## SITE PLAN REVIEW AND APPEARANCE BOARD

310 E Atlantic Avenue

Meeting	File No.	Application Type
November 29, 2023	2023-199-SPM-SPR-CL3	Level 2 with Waiver
Applicant / Property Owner		Authorized Agent
Lelyn Delray Properties 1, LLC		Steven E. Myott Architect

Consideration of a Level 2 Site Plan Modification to alter the façade of the existing building located at 310 East Atlantic Avenue, including updating the storefront frontage, providing each bay individual entrance doors, replacing the existing canopy with a metal awning, and achieving an overall Main Street Vernacular Style.

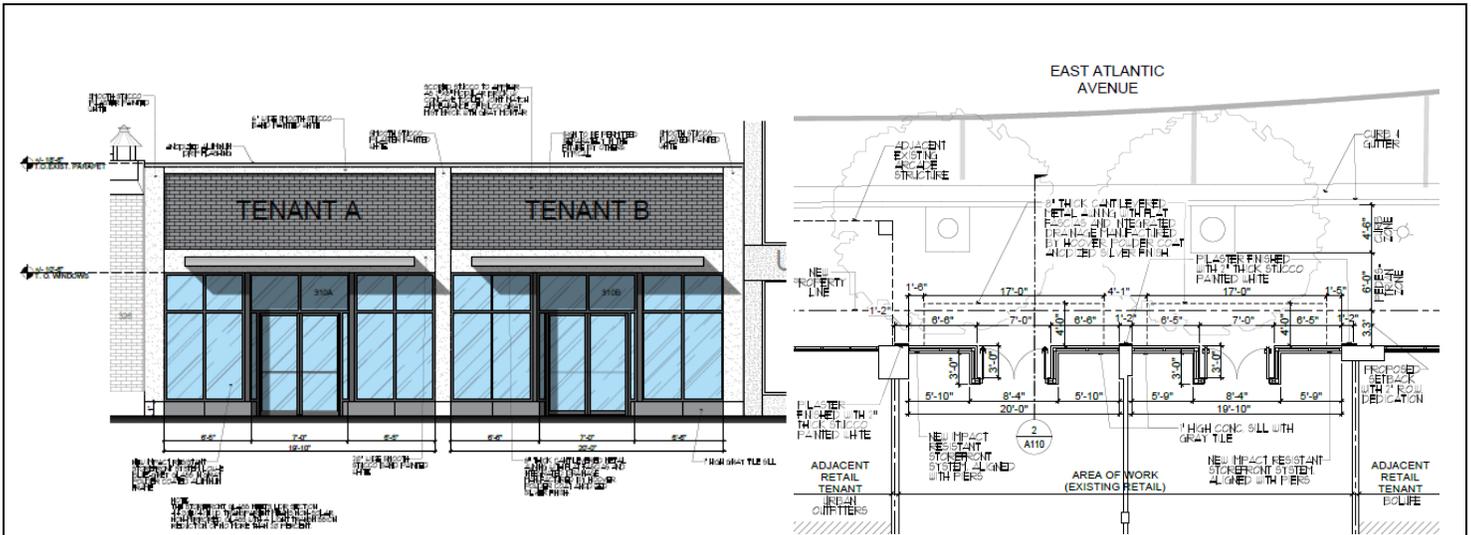
The applicant is proposing to align the façade with the adjacent buildings and modify the façade to provide each bay individual entrance doors and replace the existing canopy with metal awnings above each bay. The parapet is lowered slightly keeping with the historic parapet height. The façade consists of storefront glass, one-foot tall grey tile serving as the storefront base, smooth stucco painted white, and scored stucco to resemble a brick façade painted grey for the parapet. The proposed style is consistent with the Main Street Vernacular Style.

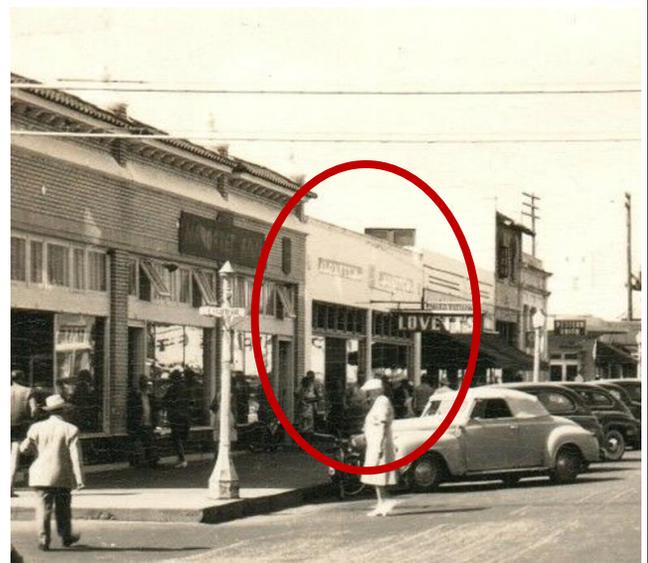
The proposed development incorporates many elements of the Main Street Vernacular architectural style outlined in the Delray Beach CBD Architectural Guidelines with Storefront frontage type. The parapet is proposed to be lowered in keeping with the historic parapet

height. The recessed façade will be aligned with the adjacent structures and the entrance doors will remain recessed to avoid conflict opening onto the sidewalk. The façade consists of a storefront that meets the requirements set in LDR Section 4.4.13(E)(4)(e). The proposed colors are comprised of grey at the storefront base, parapet, and metal awning, and white along the façade trim and along the center splitting each bay.
